Docket Number:	19-BSTD-01
Project Title:	Draft 2019 Alternative Calculation Method Reference Manuals and Compliance Software Tools
TN #:	227226
Document Title:	NRDC comments on the Draft 2019 ACM Reference Manuals and Compliance Software Tools
Description:	N/A
Filer:	System
Organization:	NRDC
Submitter Role:	Public
Submission Date:	3/1/2019 3:22:32 PM
Docketed Date:	3/1/2019

NRDC comments on the Draft 2019 ACM Reference Manuals and Compliance Software Tools

Re: NRDC Comments on the 2019 Building Energy Standards Draft Alternative Calculation Method Reference Manuals and Compliance Software Tools

Figure 1: Space heating emissions for 2019 ACM baseline system and proposed baseline system type in a 4-story mid-rise residential prototype in Climate Zone 12.

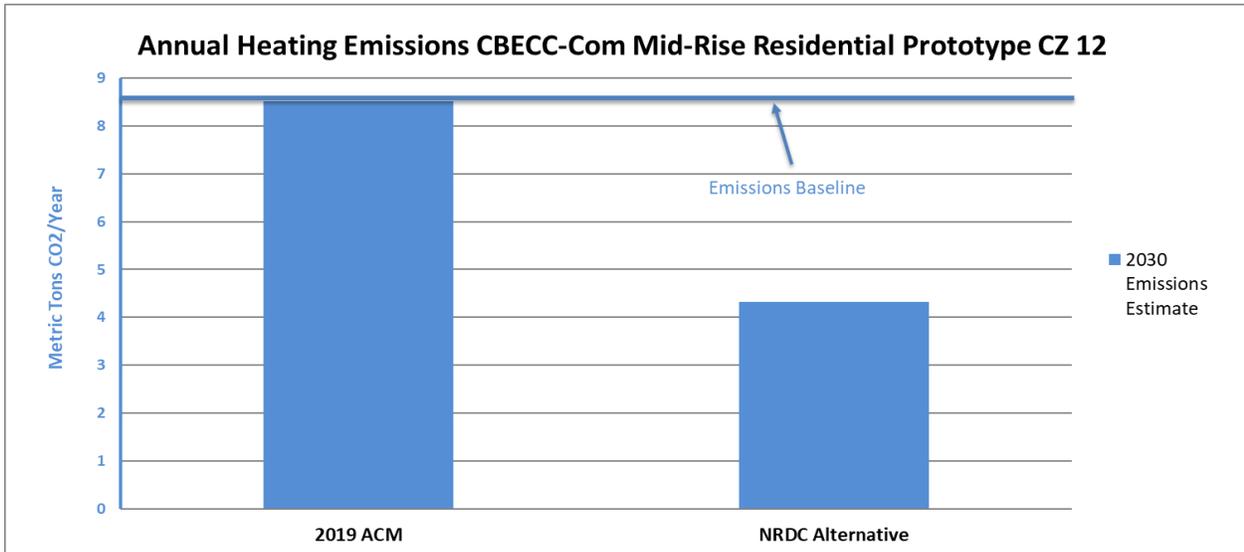
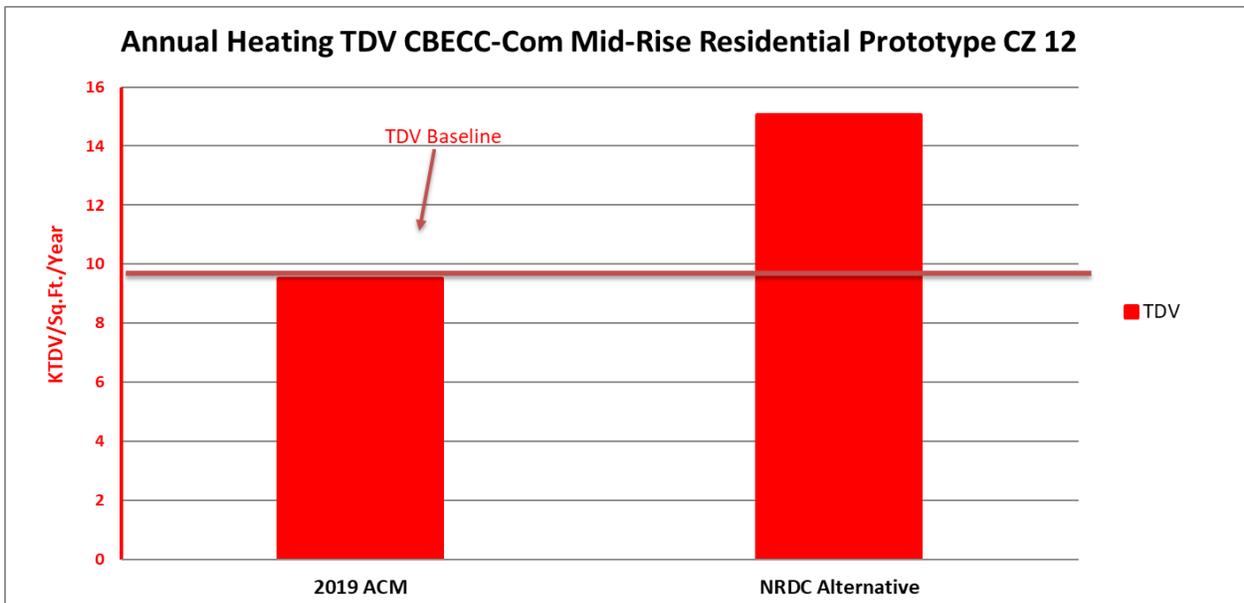
The results found that the proposed electric heating system had TDV energy use that was 160% of the baseline heating system, with emissions that were 49% lower than the baseline system. These results are shown in Figures 1 and 2.

Across the board, the modeling runs conducted showed that TDV energy use is higher and emissions are lower using the proposed electric heating system compared to the baseline system. To remove this barrier to low-emission electric options, NRDC recommends setting the baseline system based on the energy source used in the proposed design. Specifically, for heating systems we recommend that the baseline system types:

- Mid- and High-rise residential: Packaged terminal heat pumps
- Low-rise non-residential: Packaged single zone or rooftop heat pump
- Mid- and High-rise non-residential: VAV with electric reheat combined with rooftop PV

Figure 3: Space heating emissions for 2019 ACM baseline system and proposed baseline system type in a 9-story high-rise residential prototype in Climate Zone 12.

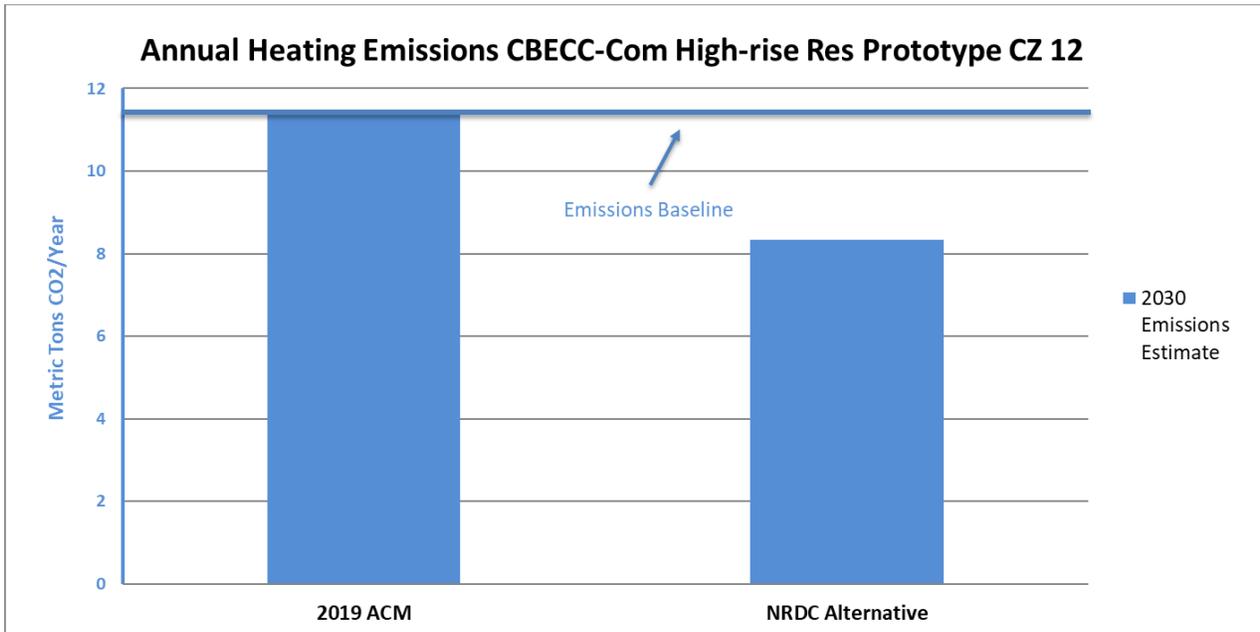
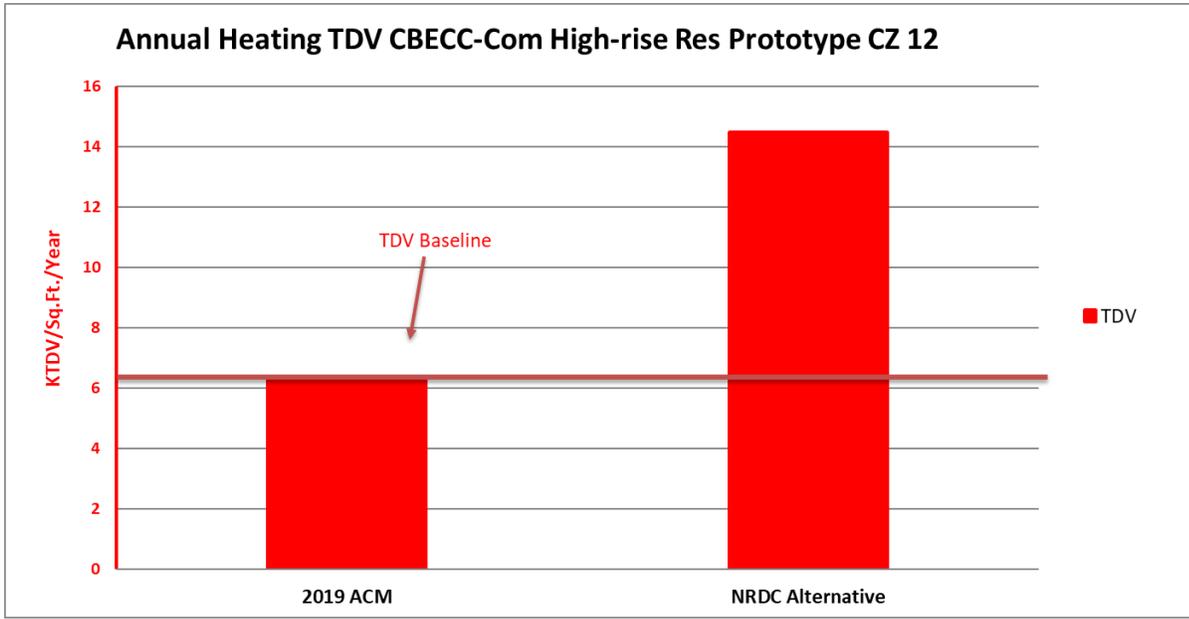
The results found that the proposed electric heating system had TDV energy use that was 230% of the baseline heating system, with emissions that were 27% lower than the baseline system. These results are shown in Figures 3 and 4.

Figure 5: Space heating emissions for 2019 ACM baseline system and proposed baseline system type in small hotel prototype in Climate Zone 12.

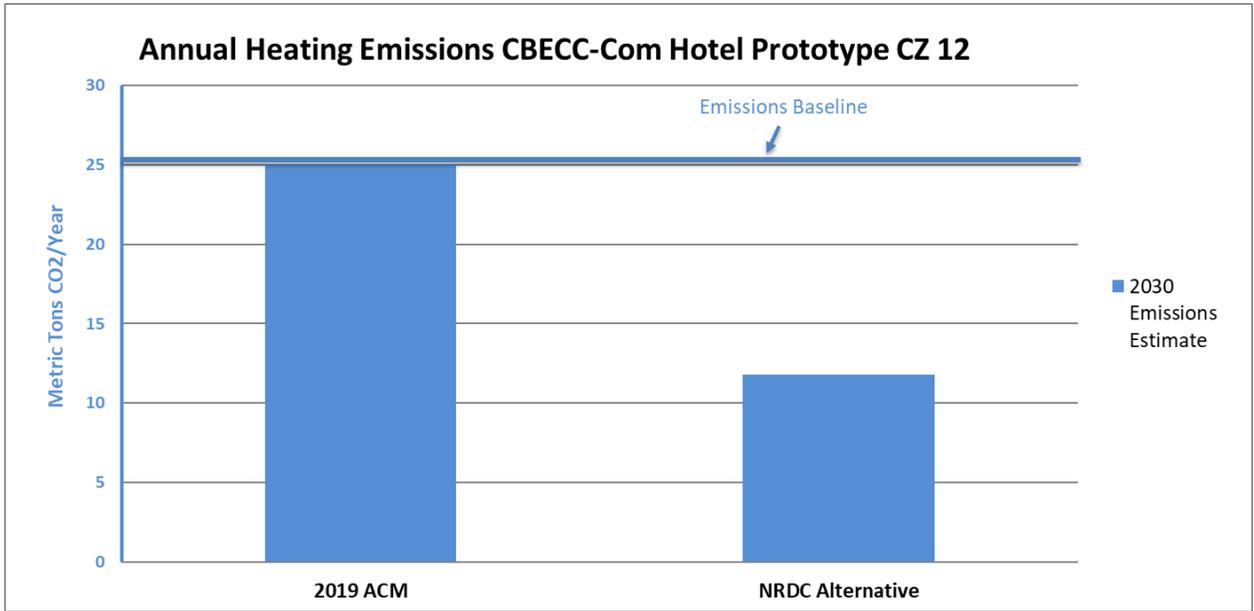
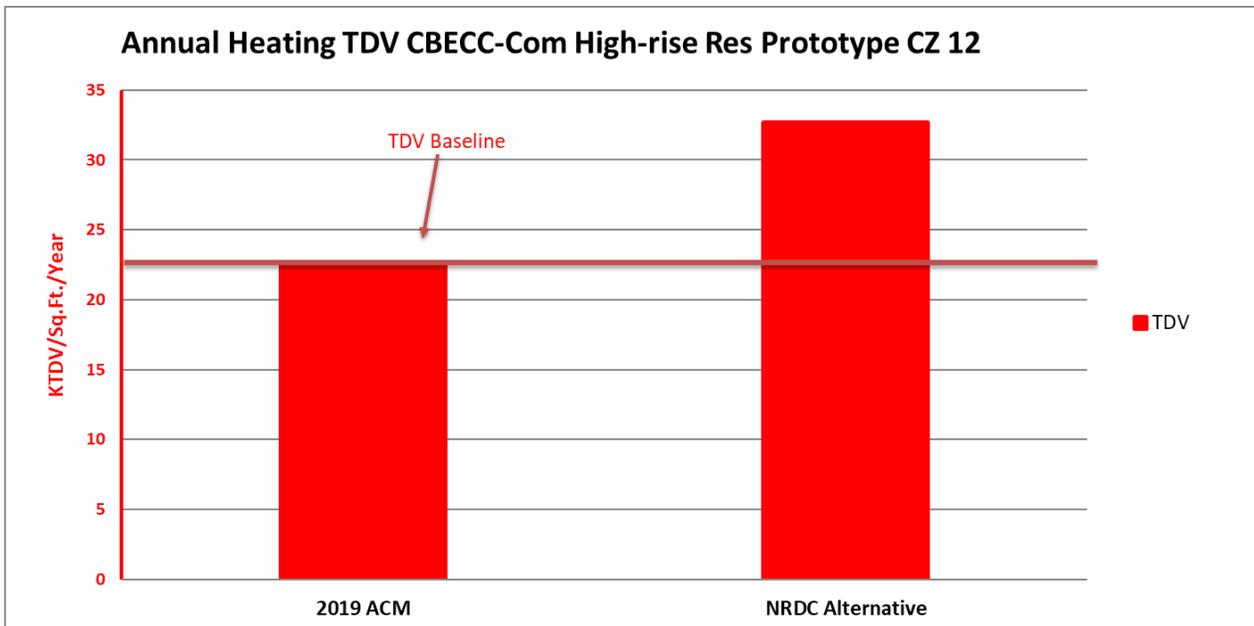
The results found that the proposed electric heating system had TDV energy use that was 145% of the baseline heating system, with emissions that were 53% lower than the baseline system. These results are shown in Figures 5 and 6.

Figure 7: Space heating emissions for 2019 ACM baseline system and proposed baseline system type in the medium office prototype in Climate Zone 12.

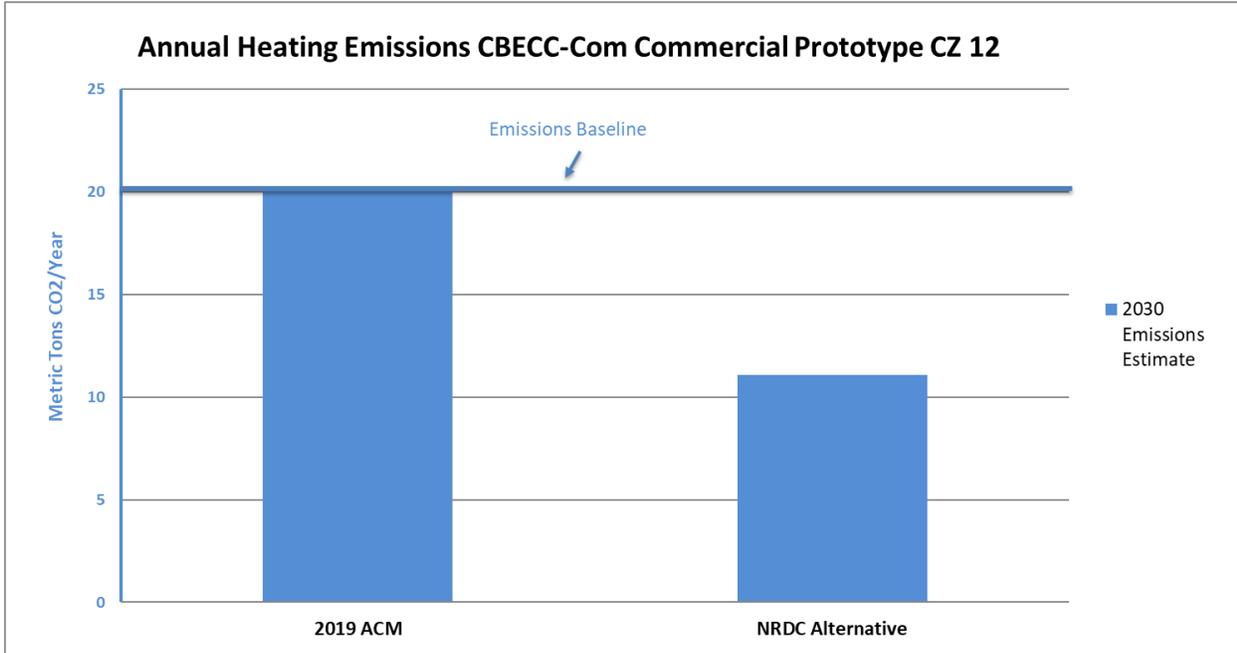
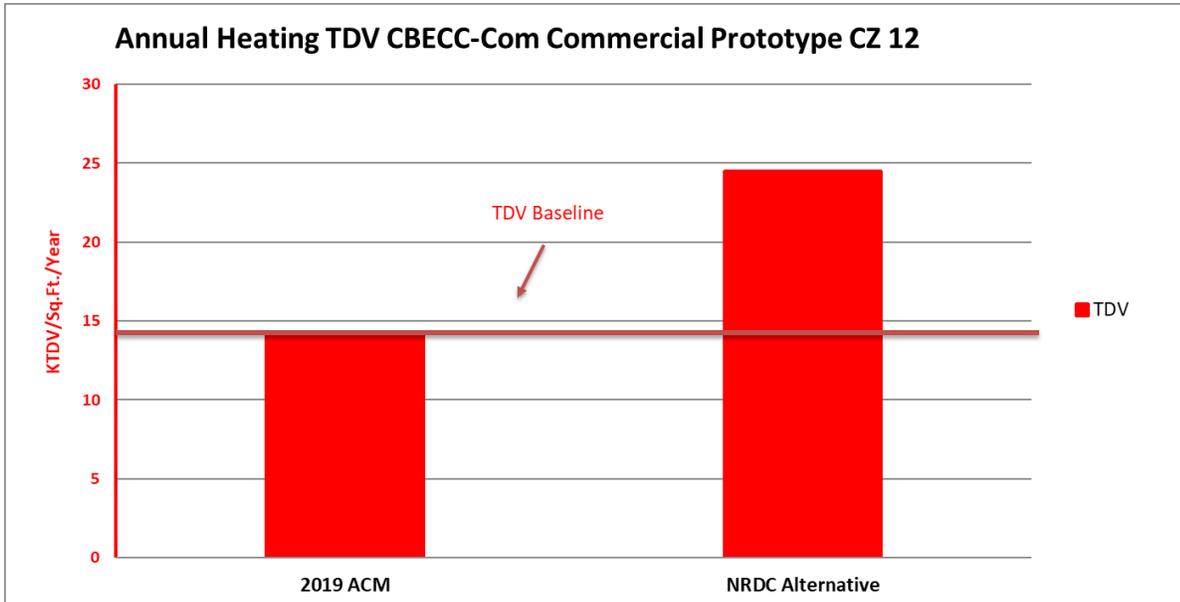
The results found that the proposed electric heating system had TDV energy use that was 170% of the baseline heating system, with emissions that were 45% lower than the baseline system. These results are shown in Figures 7 and 8.

Figure 9: Total heating energy use compared to intentional reheat energy in a 120,000 sq. ft. Bay Area office building during operational hours.⁸

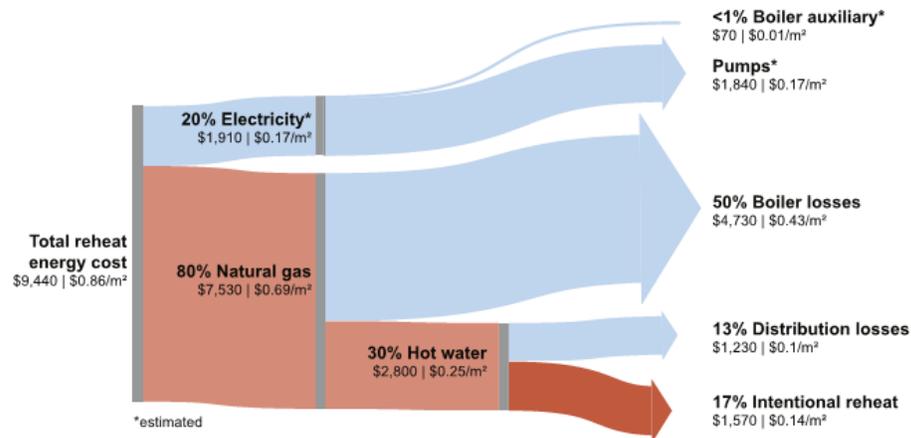
The use of the electric resistance reheat proposed system for the medium office building was chosen due to recent research conducted by the UC Berkeley Center for the Built Environment, TRC, and Taylor Engineering, indicating that losses in real-world hot-water reheat systems are significant and that VAV with electric resistance reheat may be a lower emissions and cost alternative when combined with PV.⁶ The high losses in real-world reheat systems⁷ are due largely to low heating loads in modern buildings which cause boilers to operate at low capacity factors, low heating airflows due to VAV control logic, and recirculation losses. While this research is still preliminary, it indicates that an appropriately modeled VAV with electric resistance system (potentially combined with PV) may be an appropriate baseline for proposed commercial buildings that use electricity as the proposed heating system.
